**CITY OF DOVER, DELAWARE
PLANNING COMMISSION
Monday, December 18, 2023 at 7:00 PM**

6. SB-23-03 Revised Stonebrook East Planned Neighborhood Design at McKee Road and W. Denneys Road - Public Hearing and Review of a Revised Subdivision Plan to increase the number of townhouses from 87 to 103 townhouses (increase of 16 townhouse units) and to decrease the number of garden apartment units from 168 to 138 garden apartment units (decrease of 30 units). This development known as Stonebrook East Planned Neighborhood Design (PND) proposes 241 dwelling units, recreational areas, open space, and stormwater management areas. The property is zoned RM-1 (Medium Density Residential Zone) and approved as a PND (Planned Neighborhood Design Option). The site is on the northeast corner of McKee Road and W. Denneys Road. Property Address: intersection of McKee Road and West Denneys Road. Property Owners: Hanae Harmony Properties and Stonebrook East 168 LLC. Tax Parcels: ED-05-057.03-01-01.00-000 to ED-05-057.03-01-92.00-000. Council District 1. *PND - Alternative Design Standards Requests: Townhouse Units – To permit a minimum lot width of 20 feet and reduction of minimum lot area. Garden Apartment

UTILITY PLAN

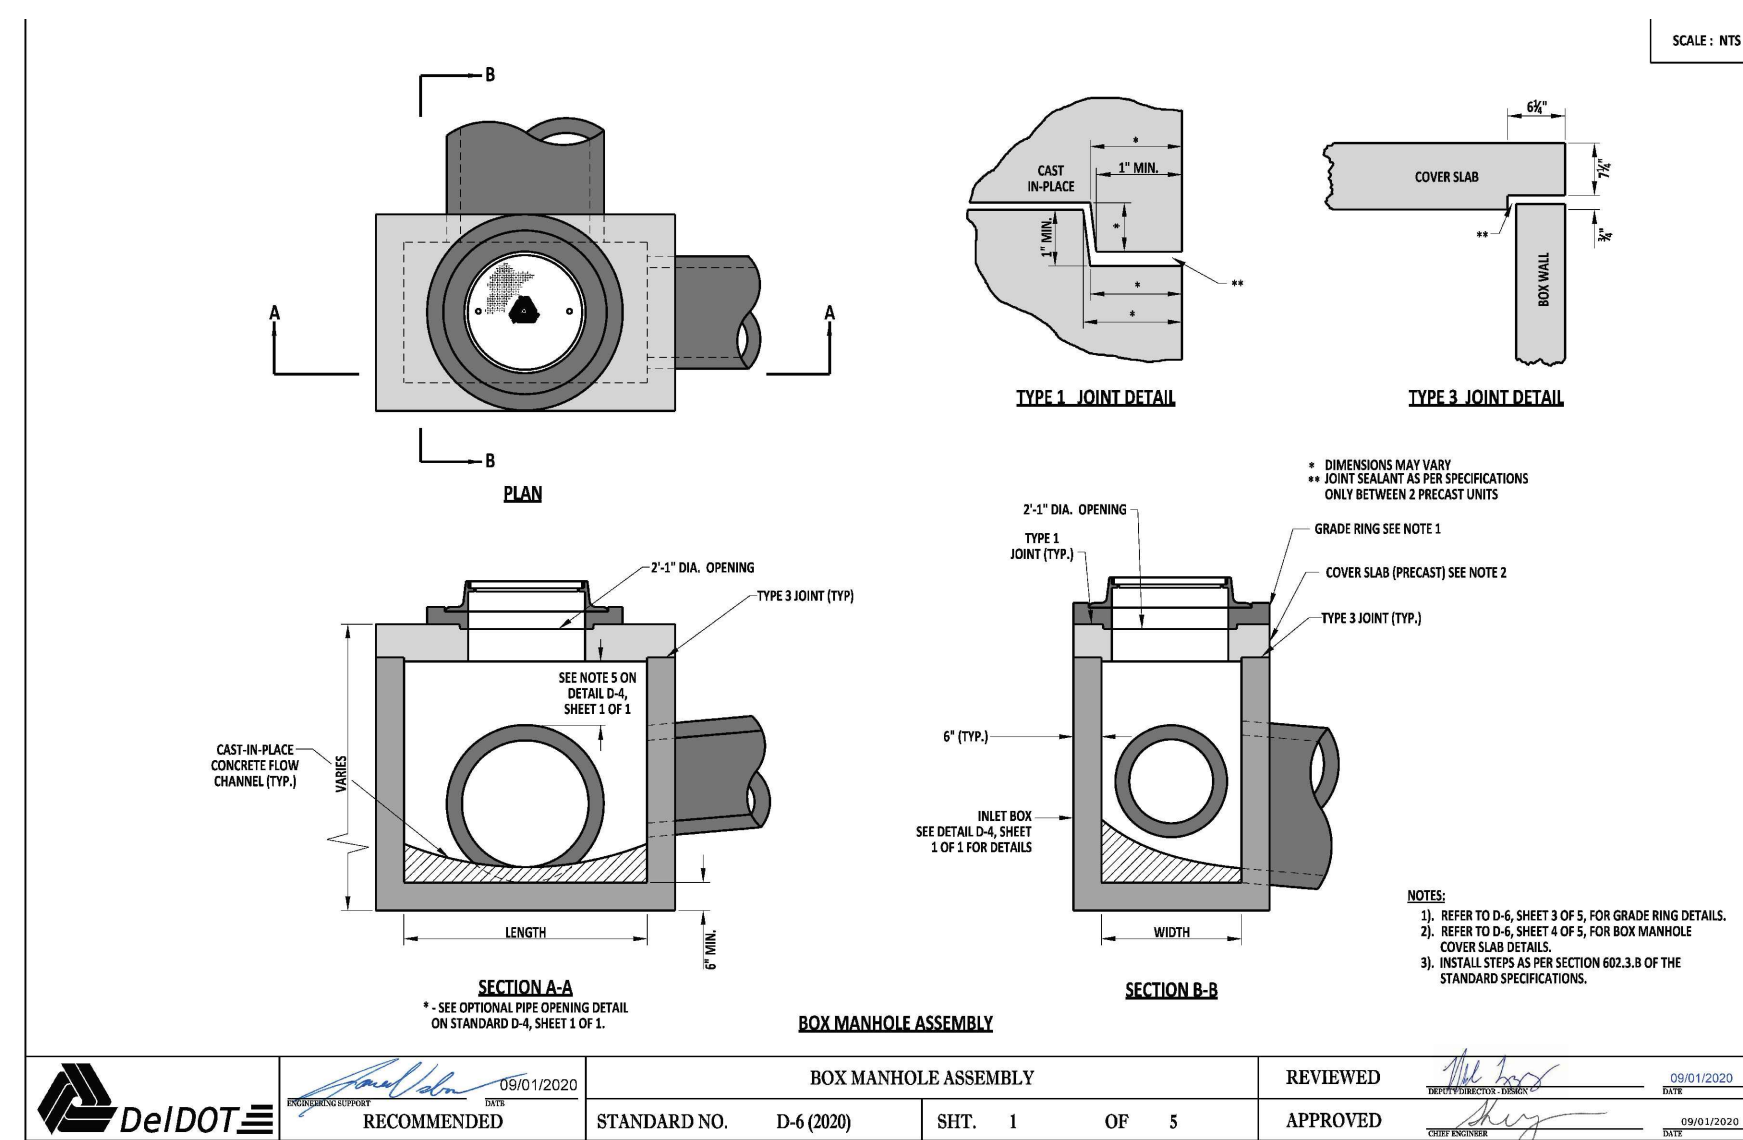
- 9) Sheet C-301 – Utility Plan:
 - a. Identify if Community Garden has a water source.
 - b. See Department of Water & Wastewater comments regarding potential Water Tank reservation area.

- c. Check General Utility Notes #9 and 10 as these may only apply to the apartment complex lot.
- 10) Sheet C-601 – Signage and Striping Plan:
 - a. Striping and Signage Construction Notes items are not labeled on this sheet but may be shown in large scale plan sheets series.

DATE: NOVEMBER 03, 2023
SCALE: 1" = 80'
PROJECT NO. 13053.CA
SHEET: L-101

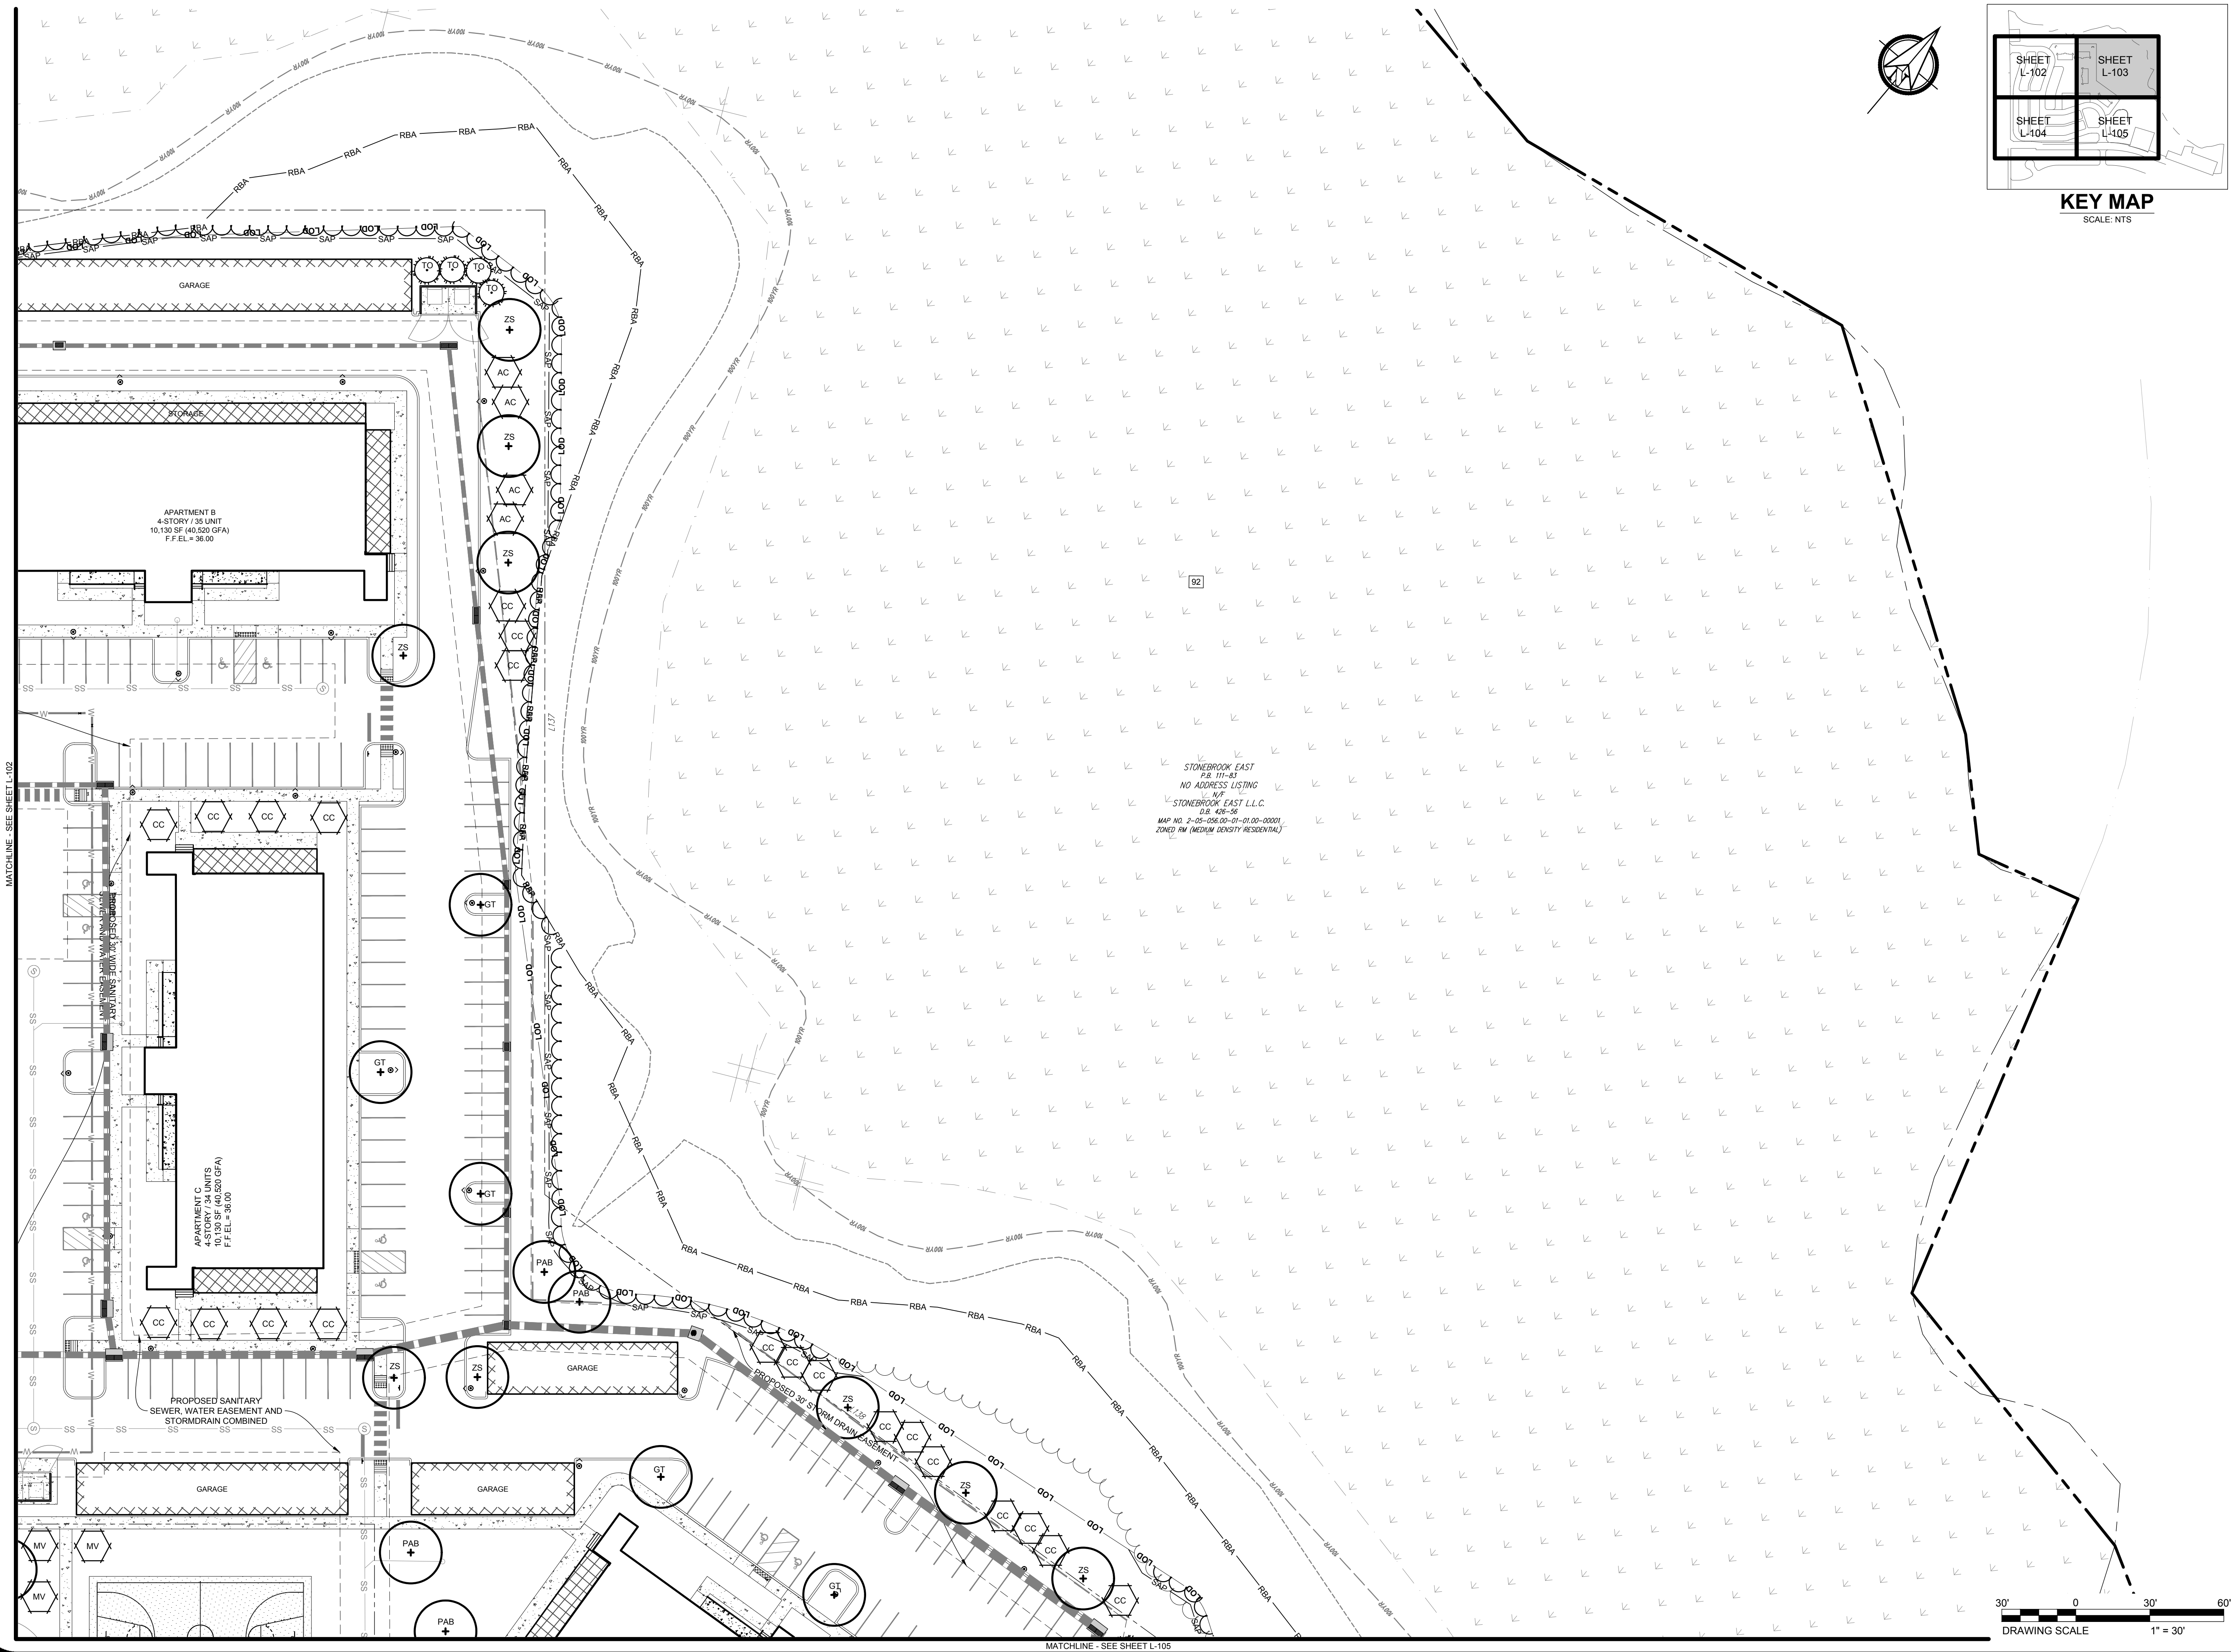
- a. Sheet L-101: Correct zoning to RM-1 for residual woodland tract.
- b. Be sure all trees are placed on definitive lots, and none are planted on the property line.
- c. Ensure there are no conflicts of tree planting locations with lighting and underground utilities as not all line and/or services laterals may be shown.
- d. Check Street/Alley light placements as some are in the street or in lot parking spaces.
- e. Please verify the correct number of plants is shown in the planting schedule that is reflected on the plans. Recheck tree counts for the following: Armstrong Red Maple, Red Sunset Maple, Bloodgood Plane Tree, and Shadblow Serviceberry.

DATE: NOVEMBER 03, 2023
SCALE: 1" = 80'
PROJECT NO. 13053.CA
SHEET: FM-101

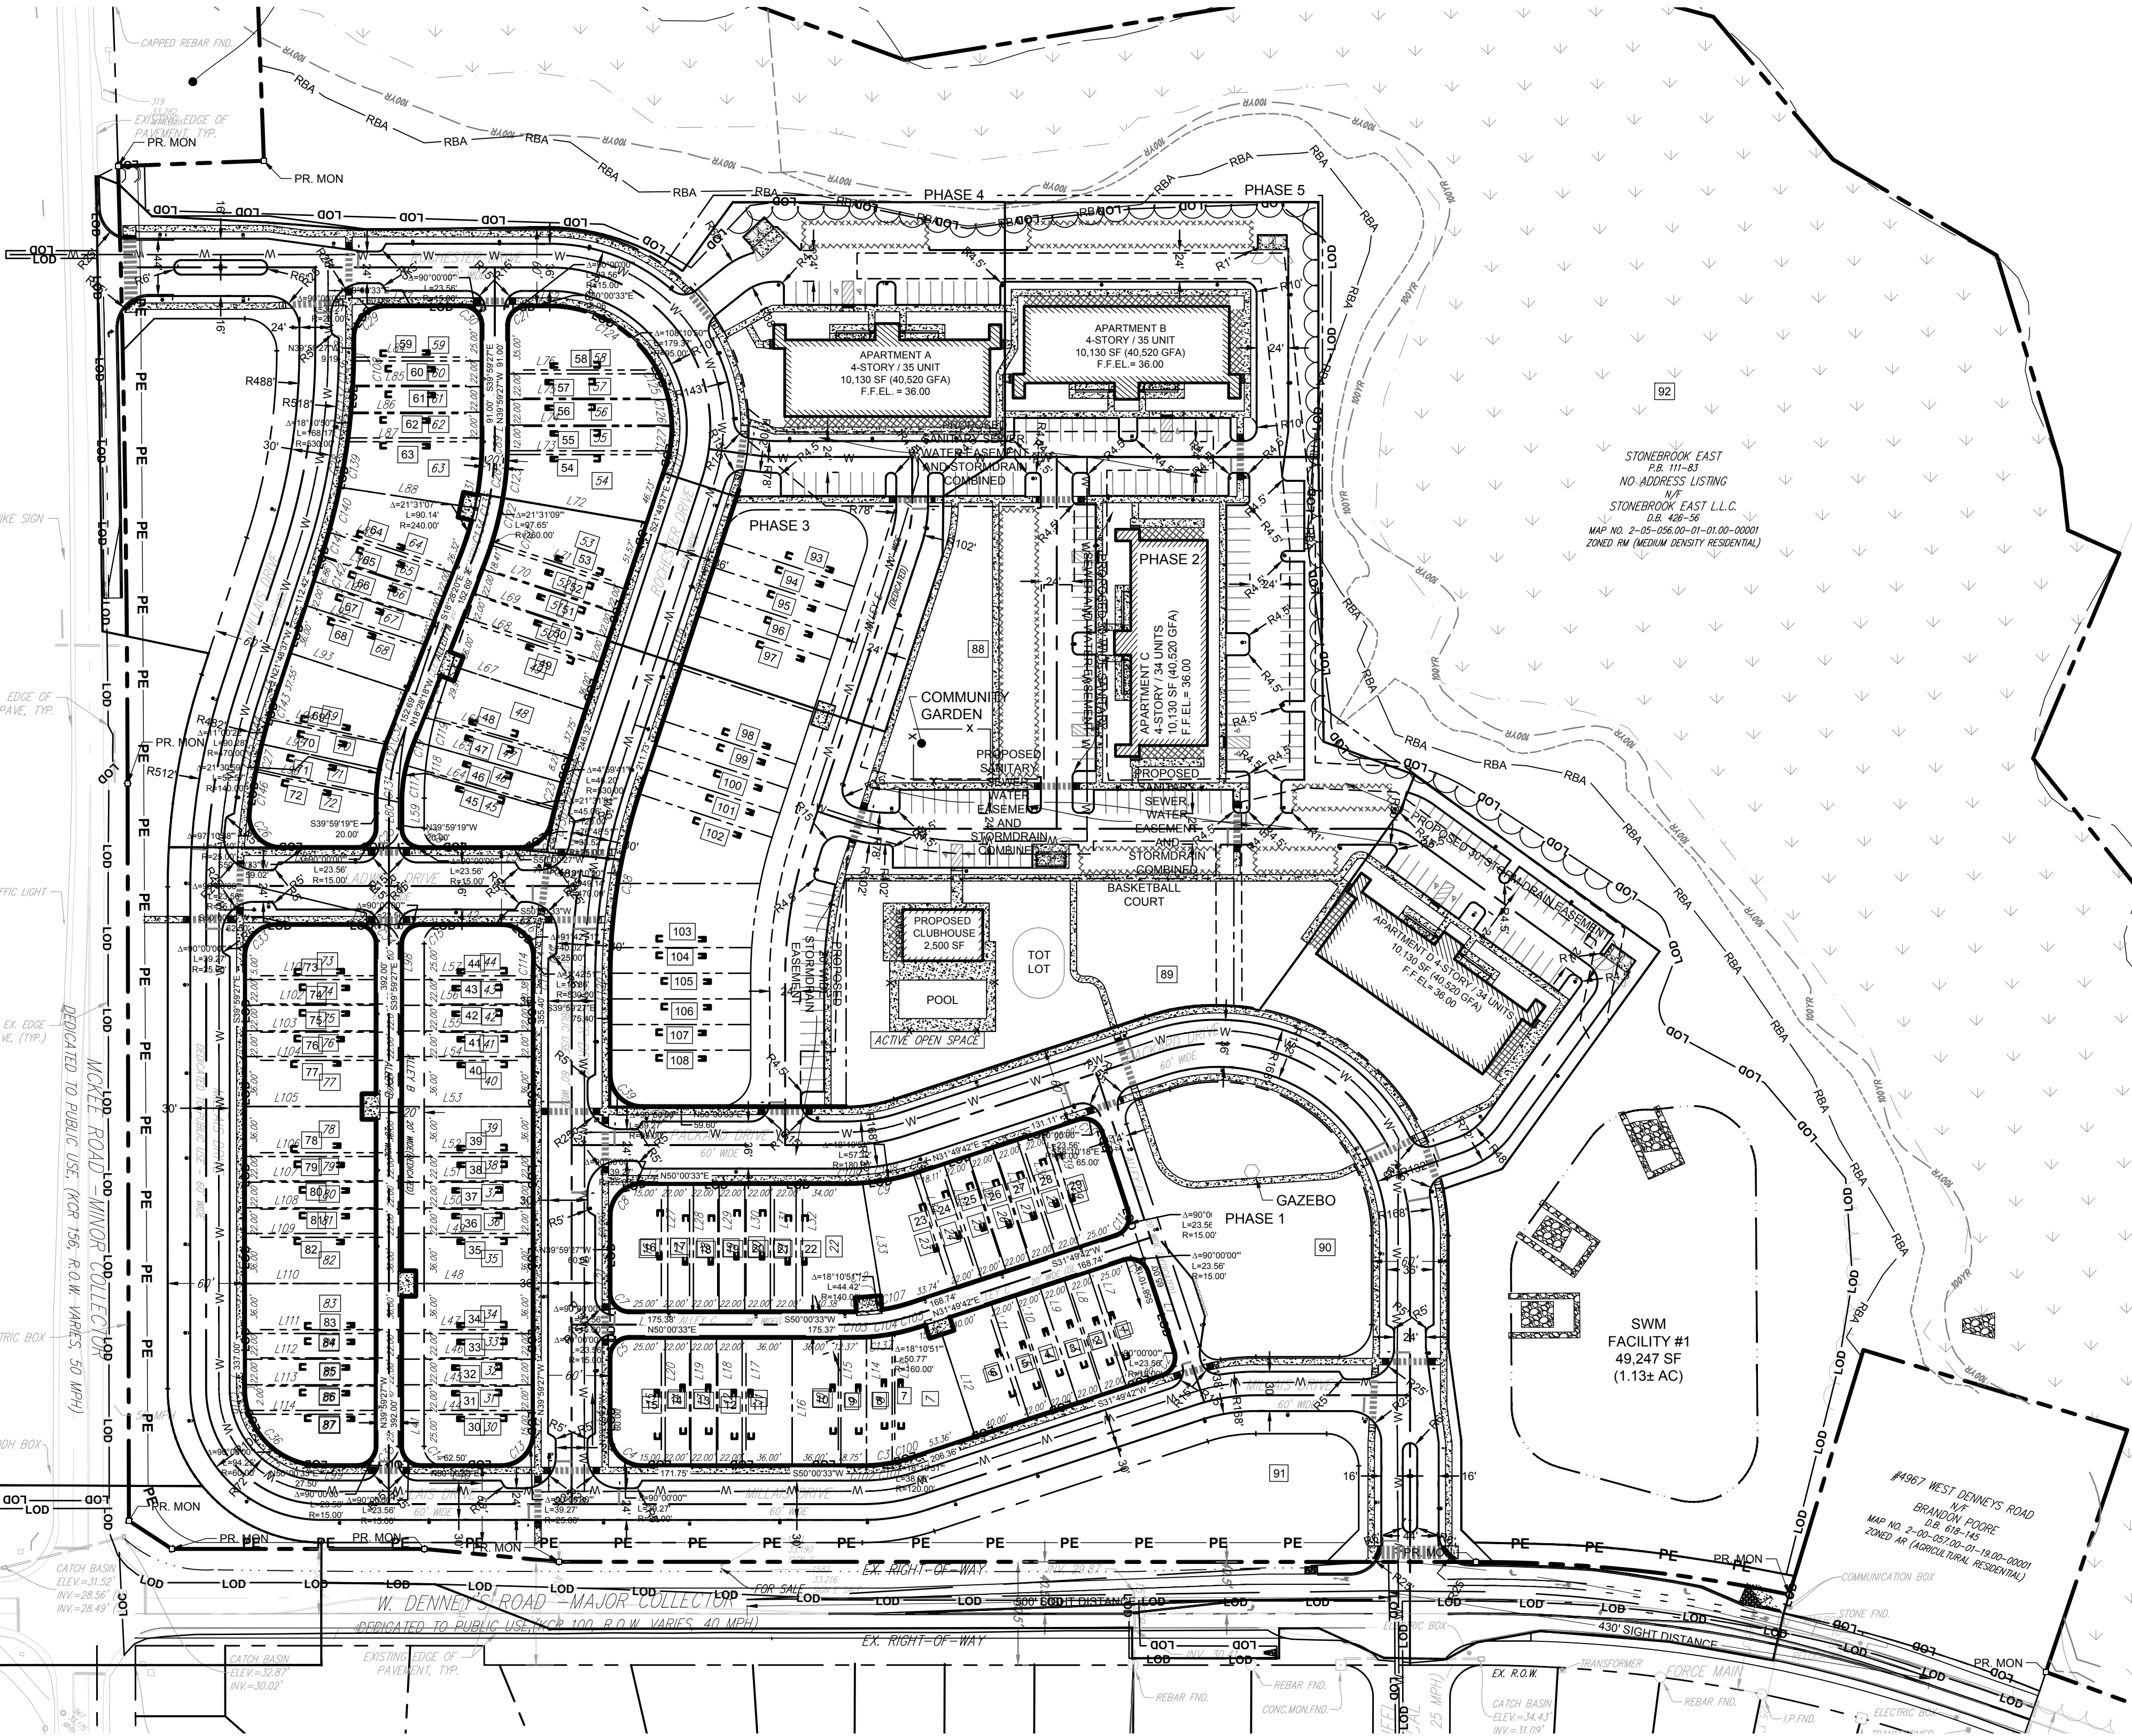
12) Sheet FM-101 – Fire Marshal Plan:
